**Scientific Analysis
Administrative Change Notice**

1. Document Number:	ANL-EBS-MD-000038	2. Revision:	01	3. ACN:	01
4. Title:	Evaluation of Potential Impacts of Microbial Activity on Drift Chemistry				
5. No. of Pages Attached:	10

Figure 6.4-1. TH Simulation (TptplI): Time Profiles of Modeled Temperatures in Fractures (Similar in Matrix) at Three Drift-Wall Locations and in the Waste Package

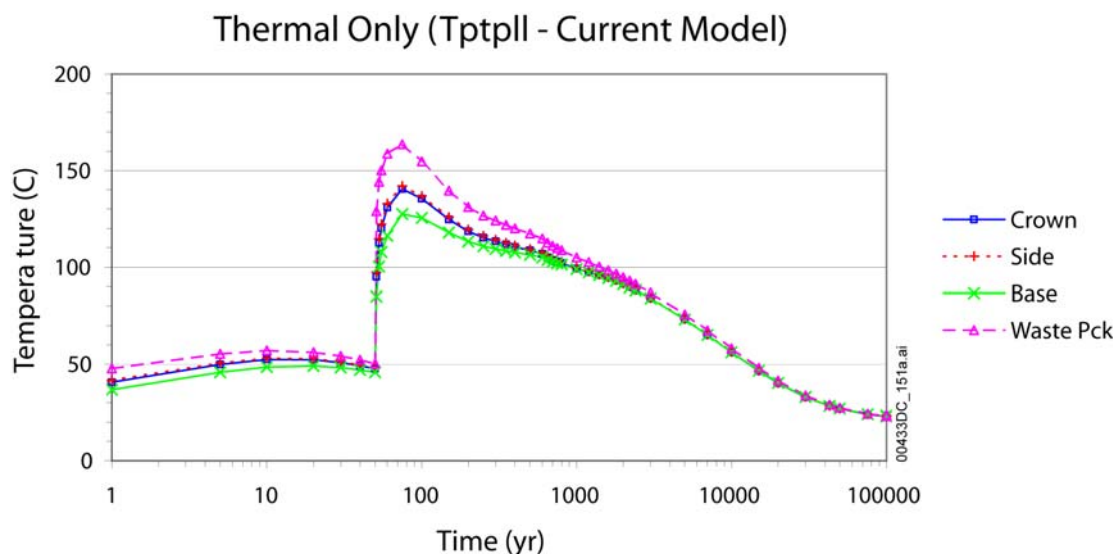
7. Affected Pages	8. Description of Change:						
4-1, 6-20, 6-21, 6-23, and 6-28	<p>Citation update (Correct DIRS as appropriate)</p> <p>Replace Citation, change:</p> <p><i>BSC 2004 [DIRS 169856]</i> To <i>BSC 2004 [DIRS 172463]</i></p> <p>This error was identified in CR 4728</p>						
4-2	<p>Added information (Correct DIRS as appropriate)</p> <p>Table 4.1-1 "Direct Inputs from Project Sources", add a last row to read:</p> <table border="1"> <thead> <tr> <th><i>Parameter(s) or Information</i></th> <th><i>Value(s)</i></th> <th><i>Source</i></th> </tr> </thead> <tbody> <tr> <td><i>Maximum surface dose rate due to gamma radiation</i></td> <td><i>1160 rad/hour</i></td> <td><i>BSC 2005 [DIRS 173426, Table 2]</i></td> </tr> </tbody> </table> <p>This error was identified in CR 4728</p>	<i>Parameter(s) or Information</i>	<i>Value(s)</i>	<i>Source</i>	<i>Maximum surface dose rate due to gamma radiation</i>	<i>1160 rad/hour</i>	<i>BSC 2005 [DIRS 173426, Table 2]</i>
<i>Parameter(s) or Information</i>	<i>Value(s)</i>	<i>Source</i>					
<i>Maximum surface dose rate due to gamma radiation</i>	<i>1160 rad/hour</i>	<i>BSC 2005 [DIRS 173426, Table 2]</i>

Source: BSC 2004 [DIRS 172463], Figure 6.5-3.
